City of El Paso – City Plan Commission Staff Report

Case No:	SUSU16-00036 Cimarron Canyon Unit One Subdivision
Application Type:	Major Combination
CPC Hearing Date:	July 14, 2016
Staff Planner:	Alfredo Austin, 915-212-1604, *austinaj@elpasotexas.gov*
Location:	East of Resler and North of Northwestern
Acreage:	97.393 Acres
Rep District:	1
Existing Use:	Residential & Commercial
Existing Zoning:	R-3A/c & C-3/c (Residential & Commercial)
Proposed Zoning:	R-3A/c & C-3/c (Residential & Commercial)
Nearest Park:	3 parks proposed within subdivision (4.228 acres)
Nearest School:	Canutillo High School (1.79 miles)
Park Fees Required:	N/A
Impact Fee Area:	West Side Impact Fee Service Area.
Property Owner:	Cimarron Hunt Communities, LLC
Applicant:	Cimarron Hunt Communities, LLC
Representative:	CSA Design Group, Inc.

ATTACHMENT 3

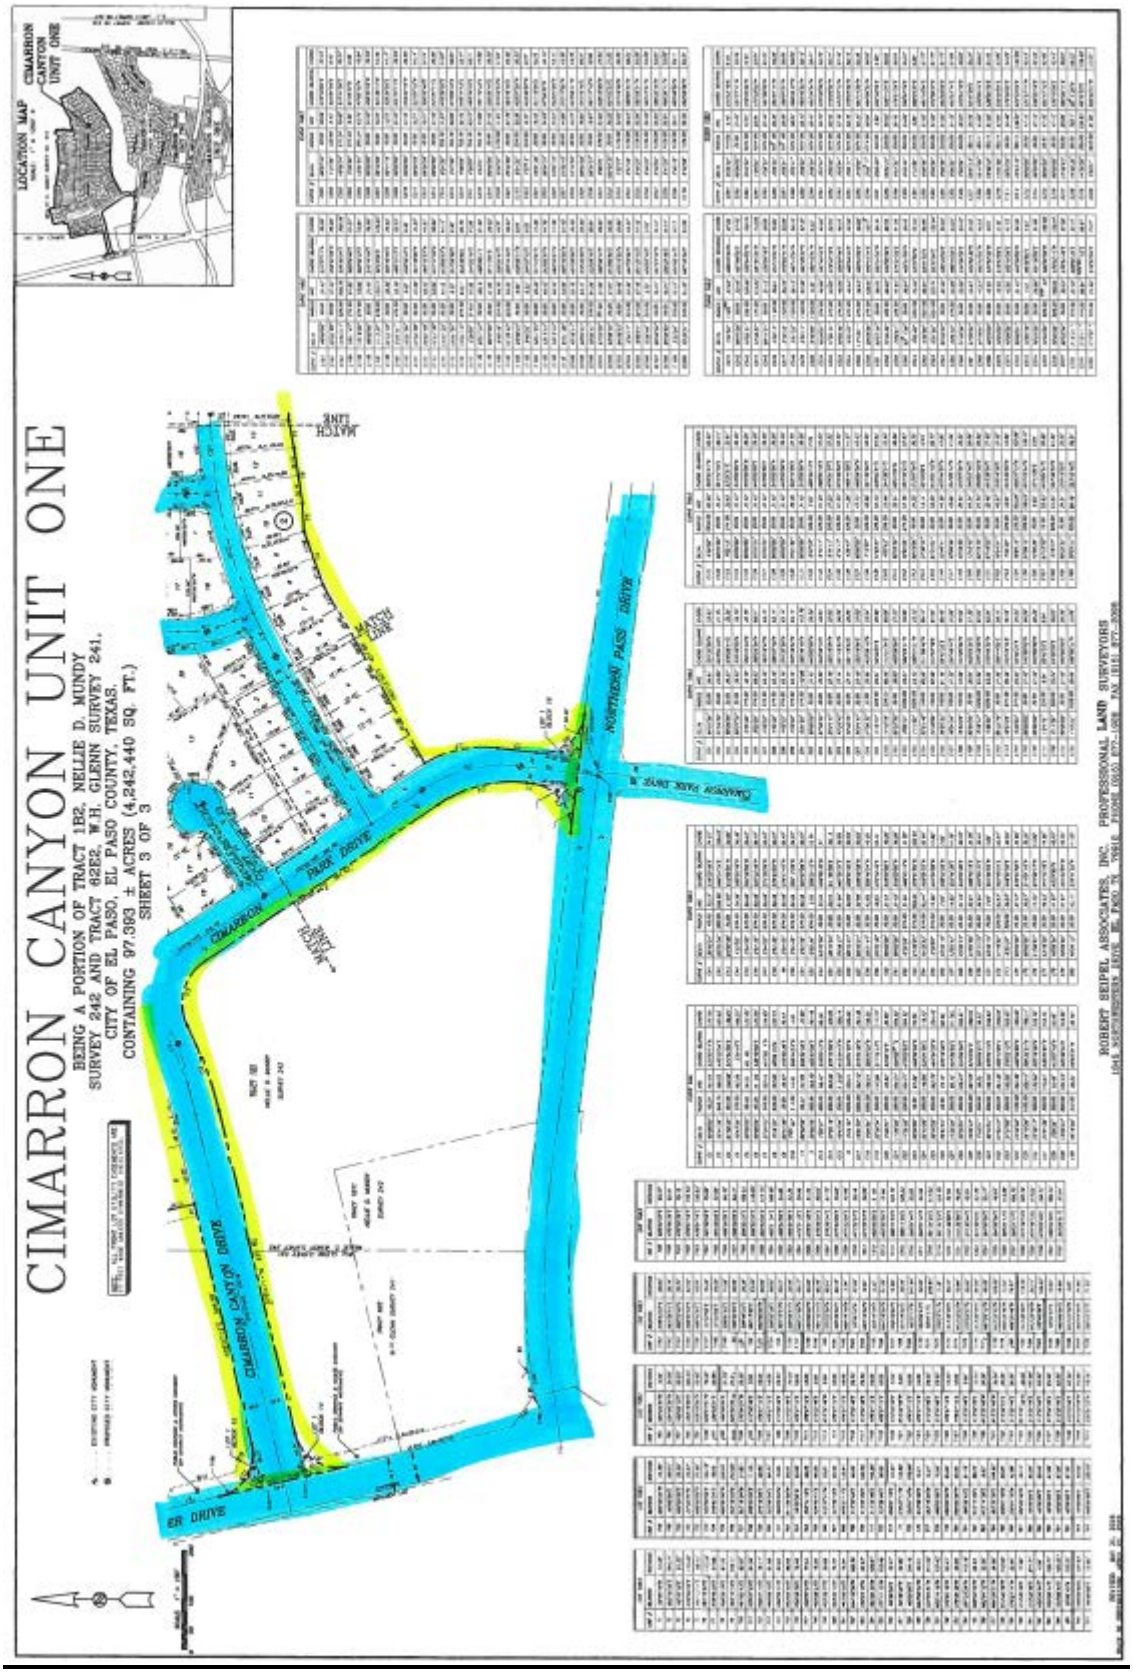
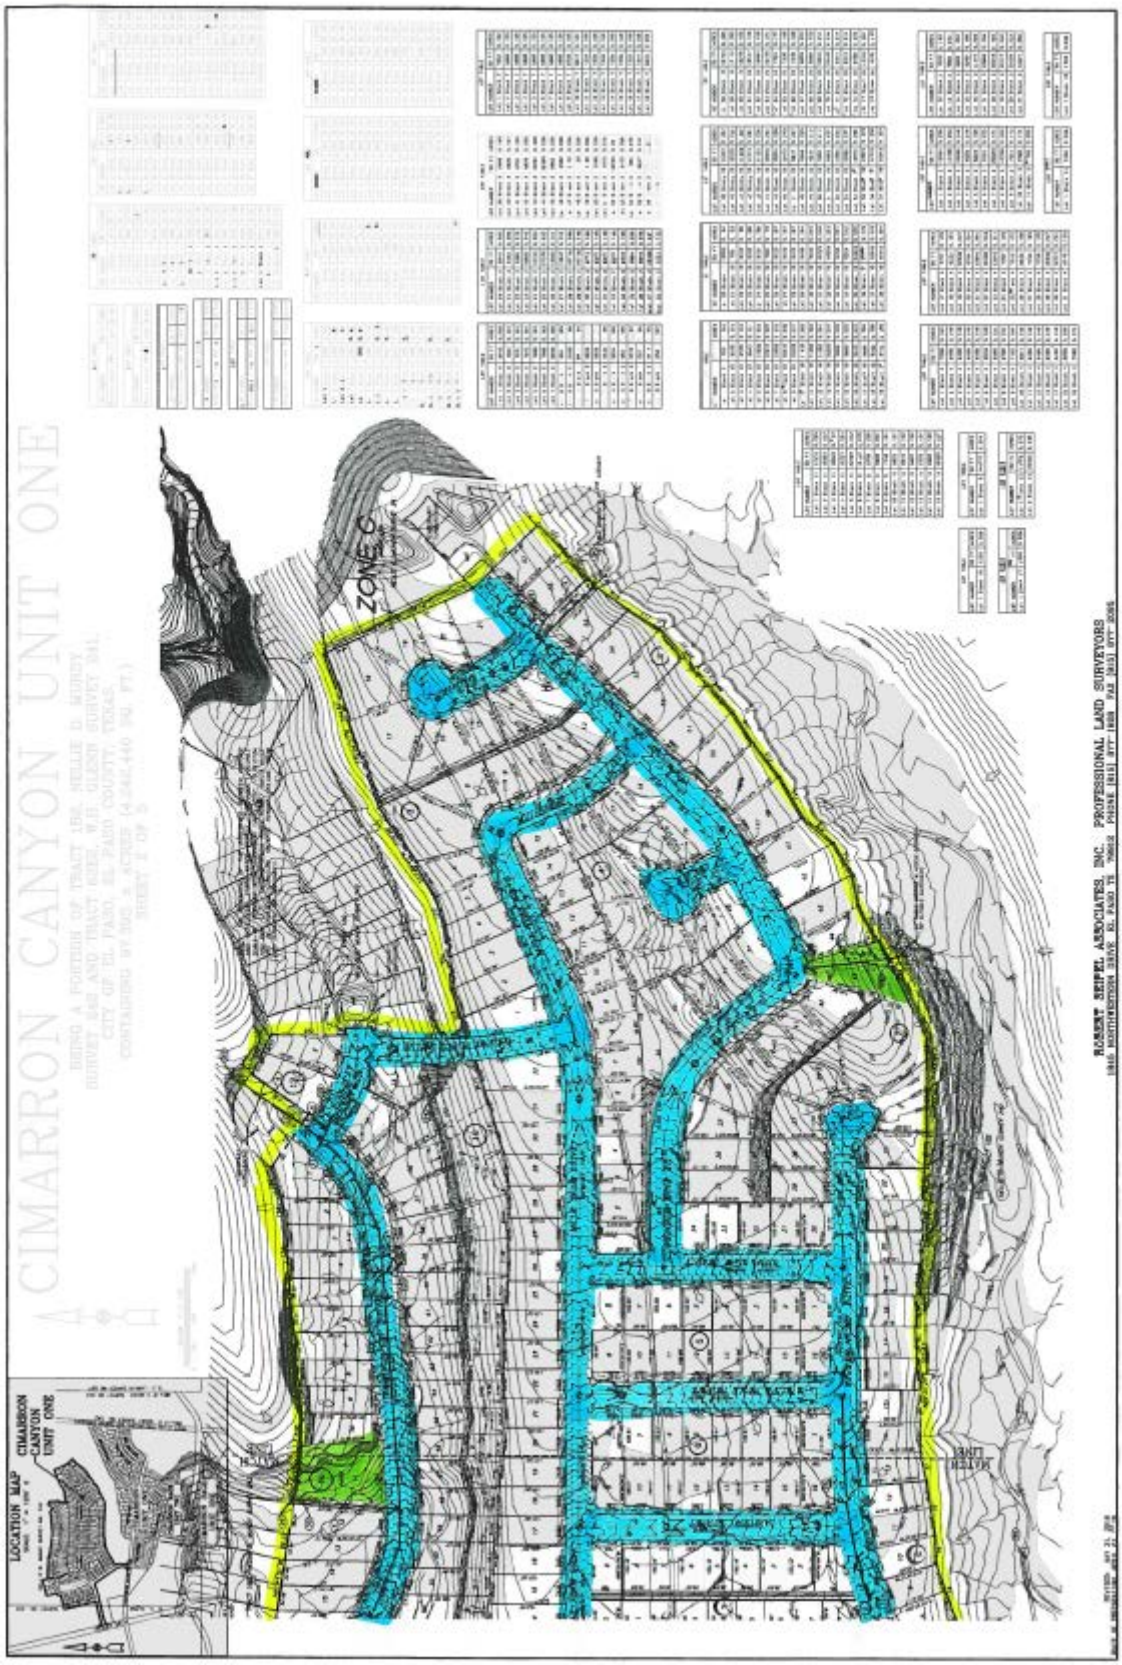
~~2.~~1. Delineate and dimension proposed pond boundary limits by bearing and distance and label whether it is to be a retention or detention pond and either public or private. Update dedication statement if necessary.

~~5.~~2. The developer shall be responsible for maintenance of all offsite stormwater management facilities unless drainage easements or rights-of-way with adequate access are provided for EPWU Stormwater Utility; run-off flowing from street ROW into undeveloped terrain or from terrain into subdivision, must do so through a temporary desilting/catch basin to avoid erosion of either the street or terrain.

~~6.~~3. The proposed subdivision is located near a potential sediment flow source. At the improvement plan stage EPWU requires the Engineer to account for sediment volume in all calculations used to size stormwater drainage structures to prevent sediment from clogging the proposed crossings. Provide sufficient access for mechanized maintenance equipment and vehicles. Drainage key item 1 must be at least 18" per DDM.

~~7.~~4. At the Improvement Plan stage, the developer shall provide the design and calculations for the Retention/Detention Pond or Dam upstream of Bobcat Hollow Dr., for review and approval. Show entire extents of offsite contributing watershed areas.

~~8.~~5. Some of the drainage easements or ROW's are not identified as "Public" or "Private; please label them accordingly.

~~9.~~6. Show existing contours as dashed lines and leave the proposed as solid lines.

~~10.~~7. All ROW improvements shall comply with ADA and TAS.

The district request that streets traveling south to north be addressed so that the addressing increases from south to north as these streets should try to follow addressing on N Resler. Previous addressing increases in the opposite direction but is not consistent. Those addresses tend to be in the 7300 or 7400 range. Follow the example of addressing for The Falls at Cimarron Unit 2.

Regarding addressing on Mule Team Dr, the District recommends that addressing for lots 8 – 12 and 16 – 18 also have addressing in the 7300 range or the street be split into two street names to allow for different addressing schemas.
